BAR Meeting
July 20, 2016

ISSUE: Partial Demolition/Capsulation and Certificate of Appropriateness for Addition and Alterations

LOCATION: 106 Quay Street

BAR2016-00188 & BAR2016-00189

PROPOSED ROOF PLAN

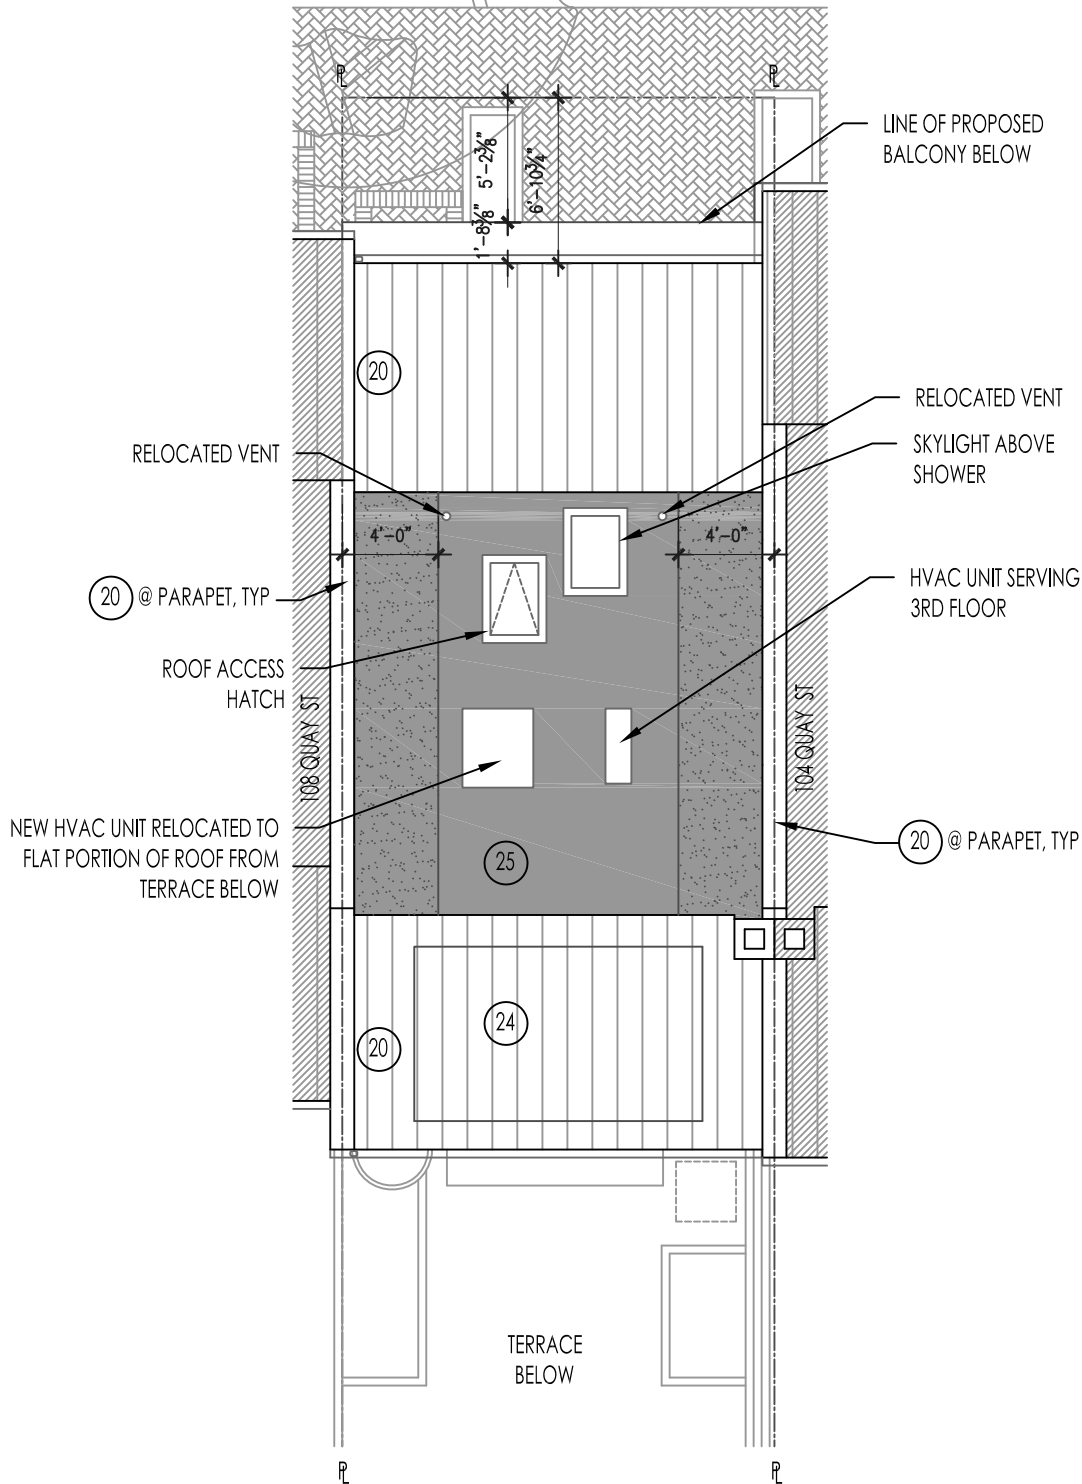
Staff recommends approval of the waiver of the rooftop HVAC screening finding that it will be located so as to be minimally visible.

- C-1 Applicant must request waiver of HVAC screening for new unit to be located on flat roof. If waiver is not granted, Zoning will require screening on all four sides.

ASK
3.2

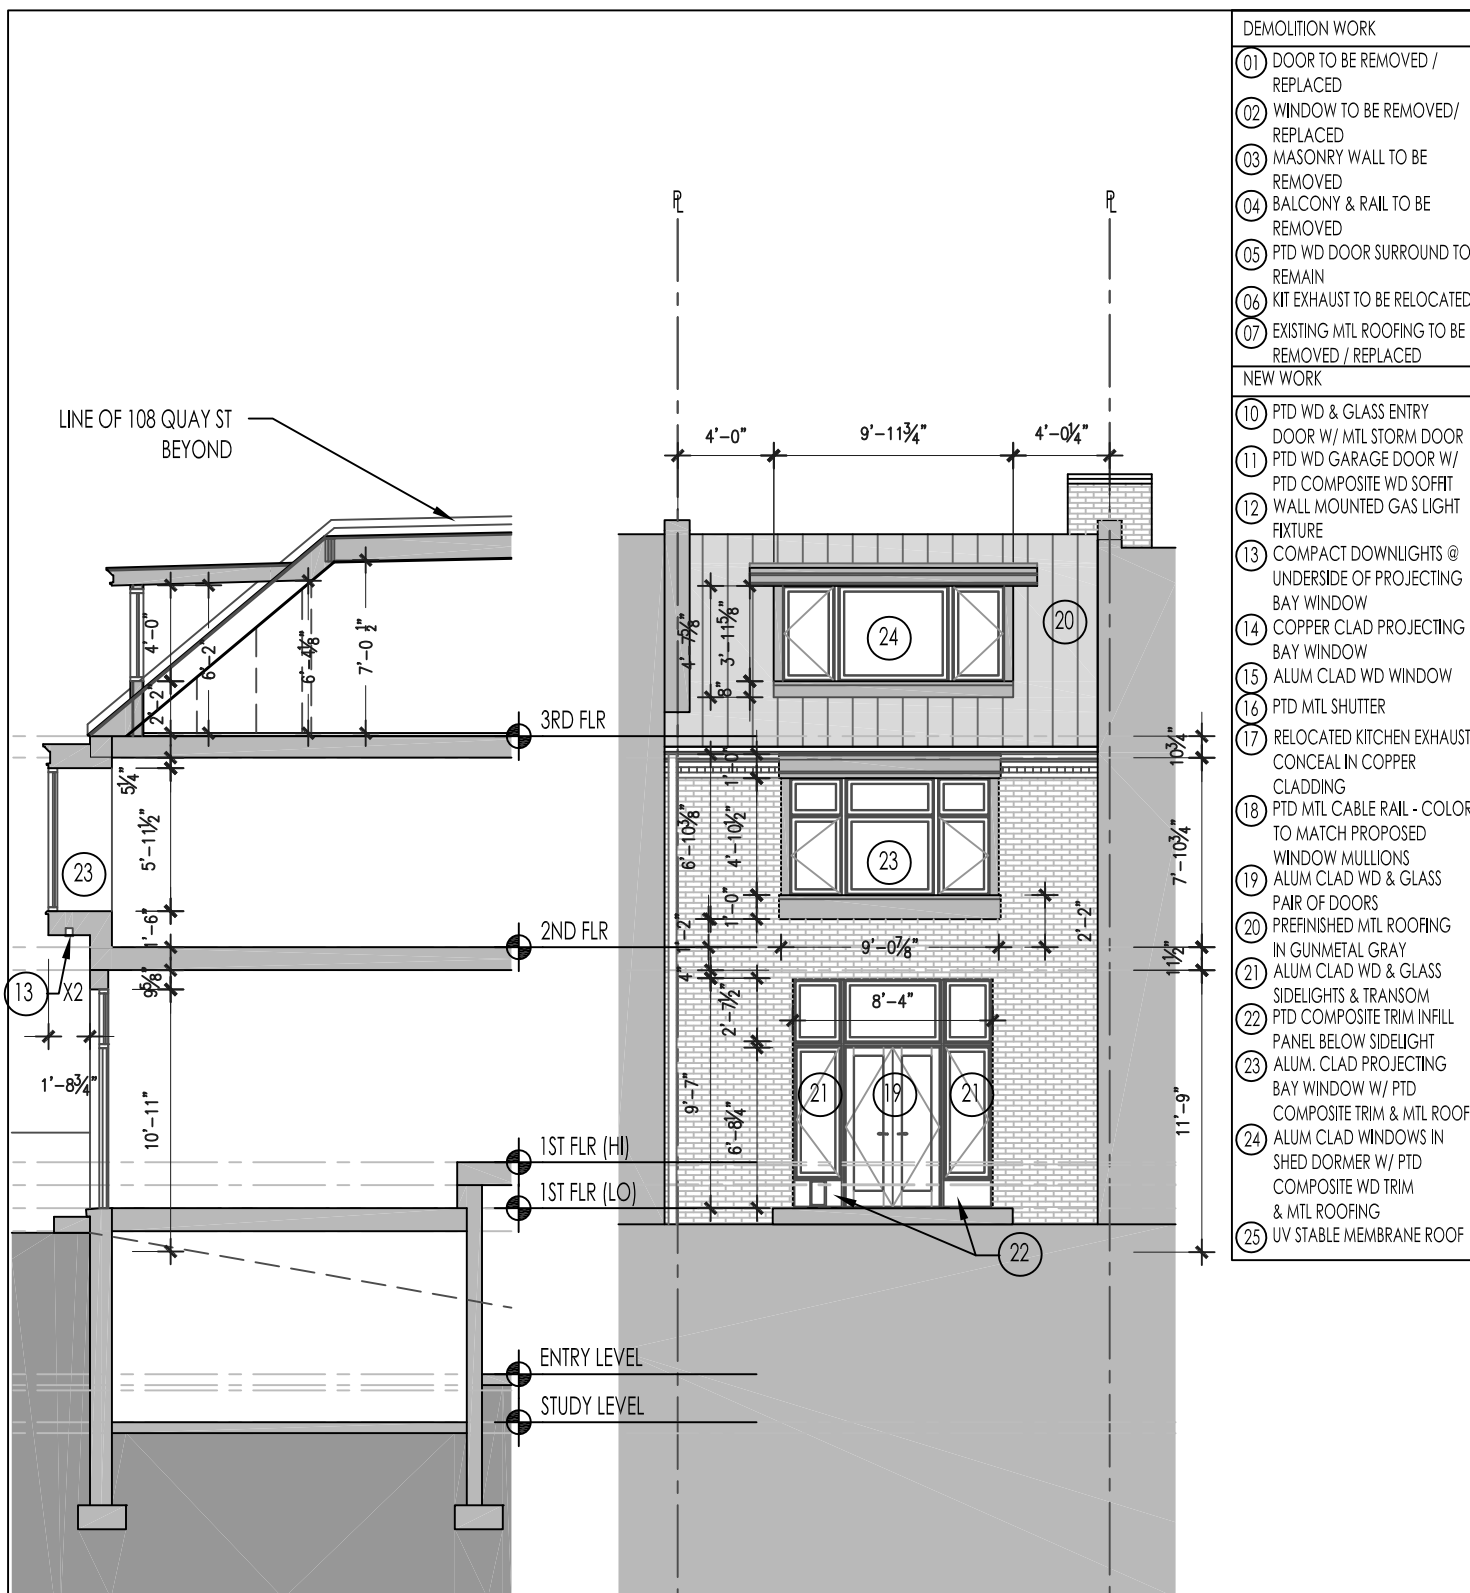
1. Doors and windows must be in accordance with the BAR's approved policies.
2. Either rear elevation design may be used at the applicant's discretion, with final approval as part of the building permit review process.
